ADDENDUM

Issued: 2/1/2022

Addendum No. 01
New City Library Addition and Renovation
VMDO Project No. 1301

ELECTRICAL LOWER LEVEL NEW WORK RCP

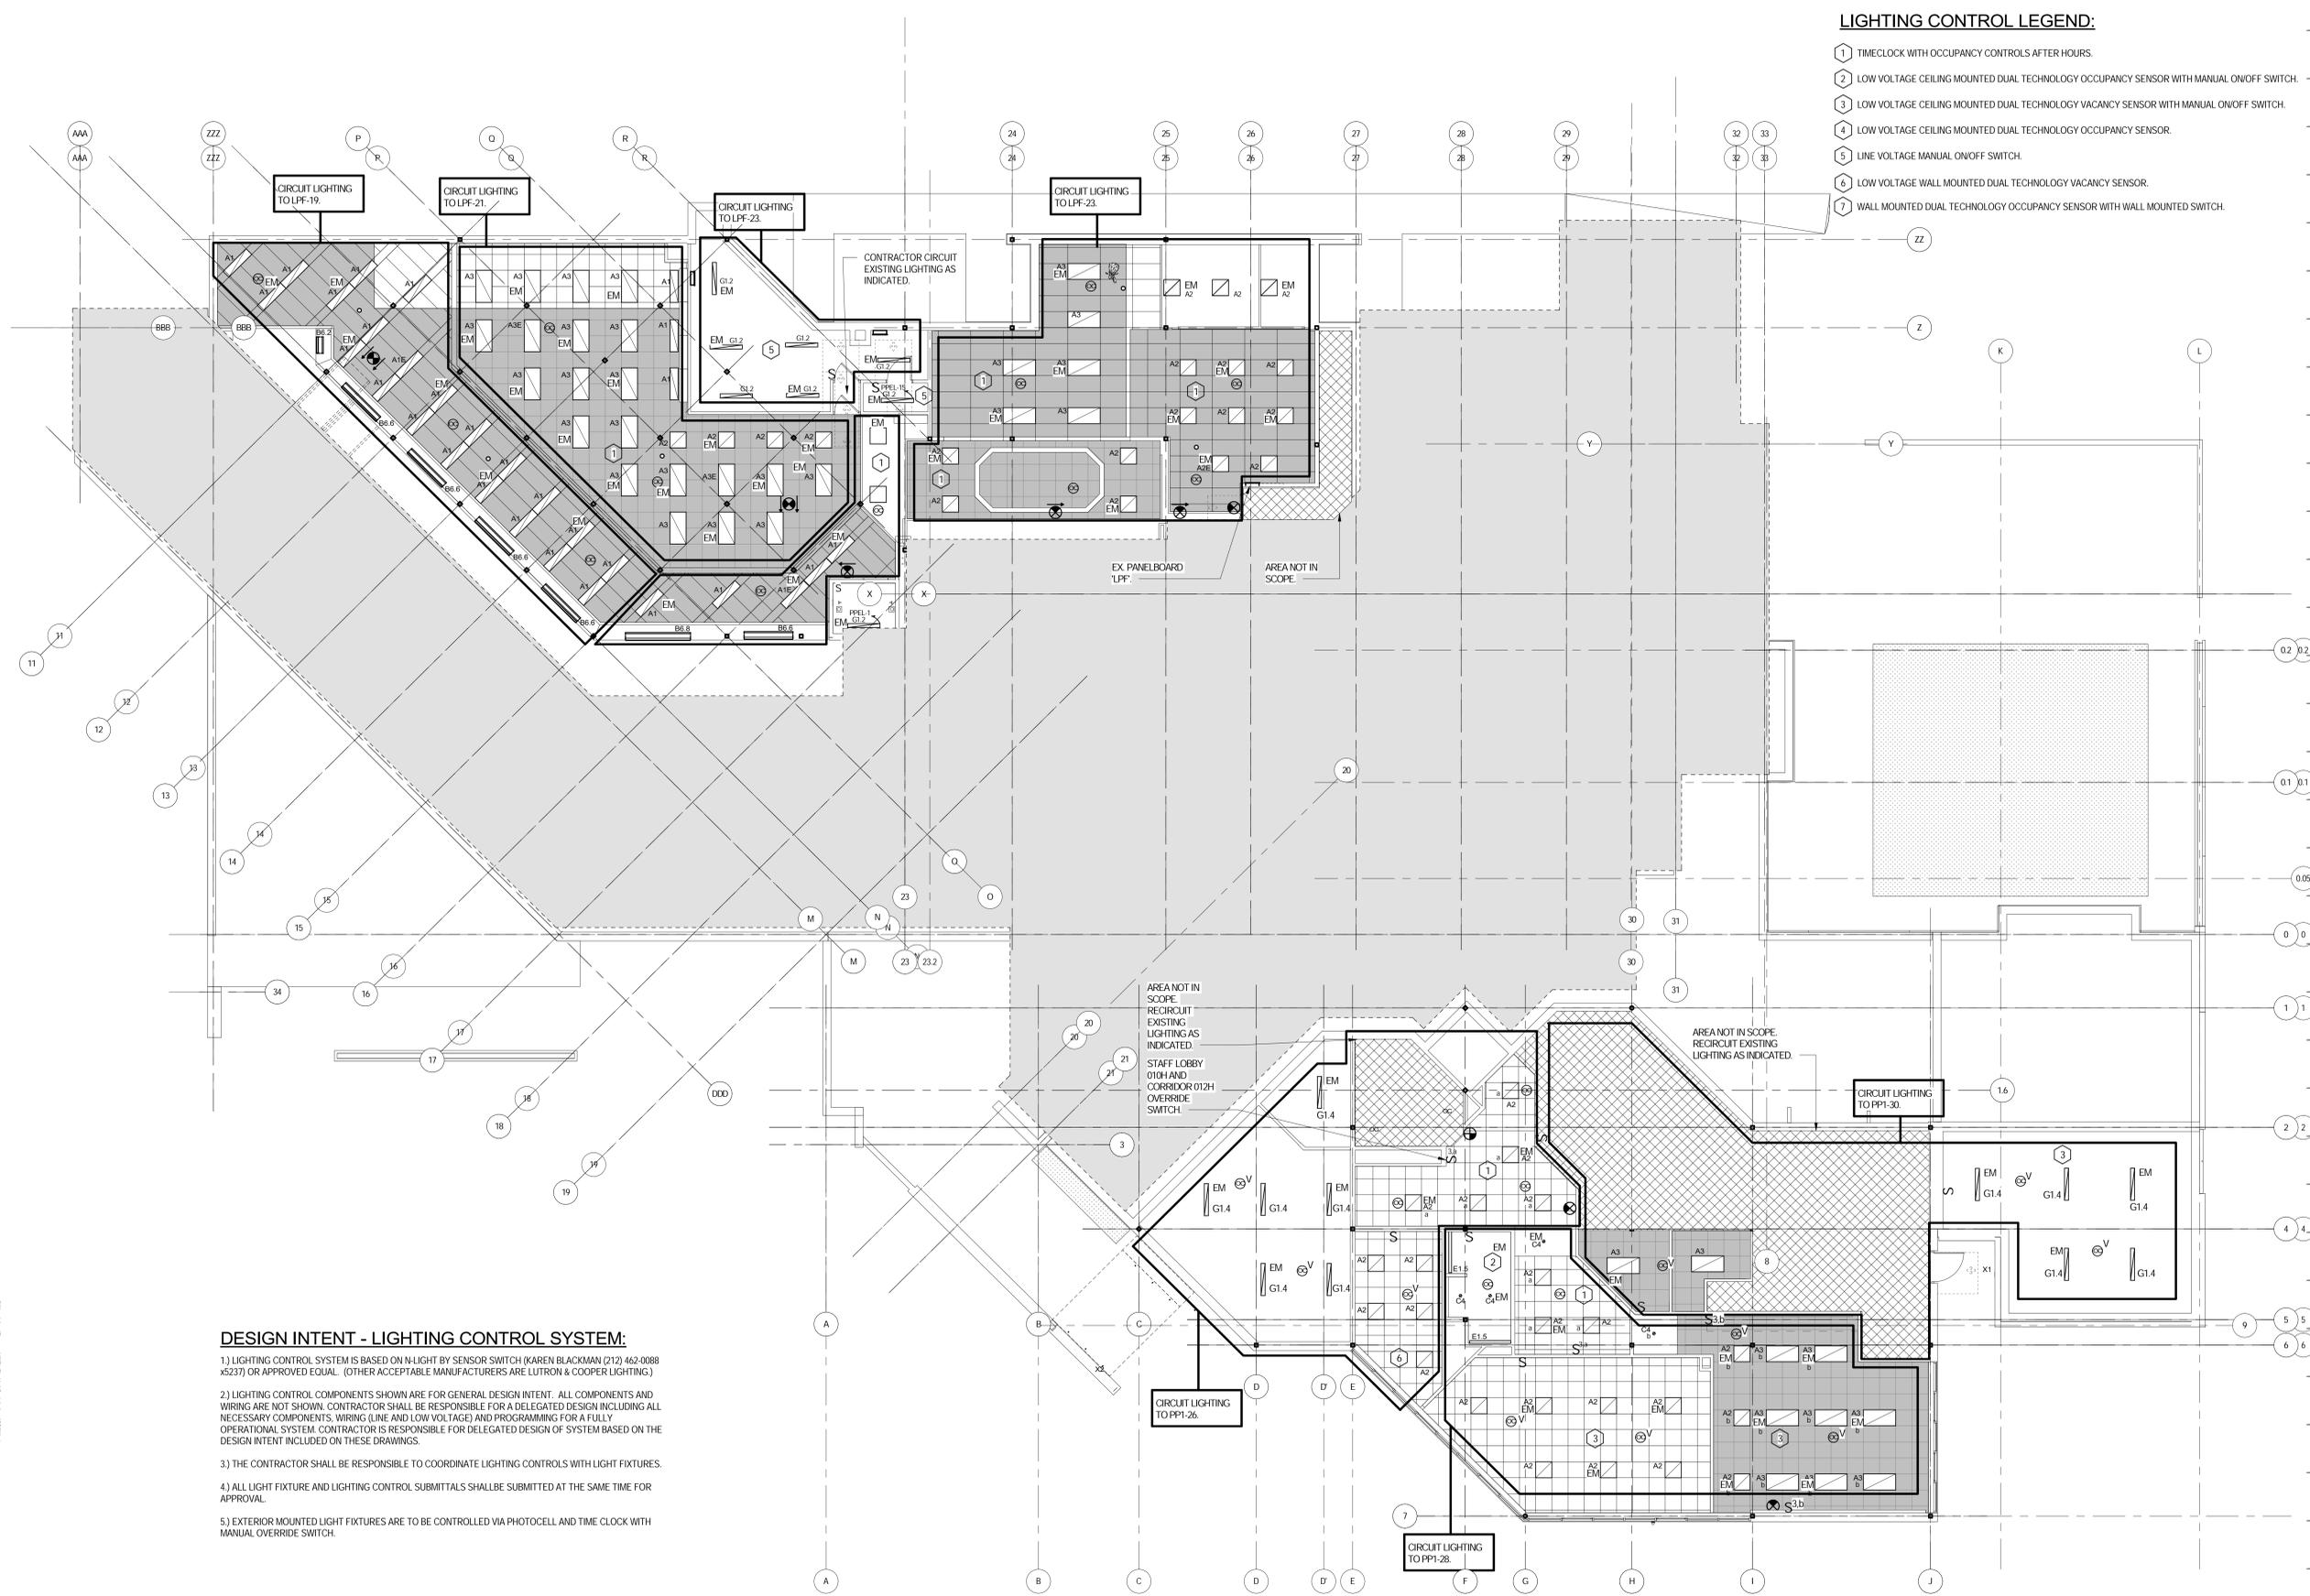
- Addition of Electrical Site Plan
- Completion of lighting circuiting and fixture specifications.
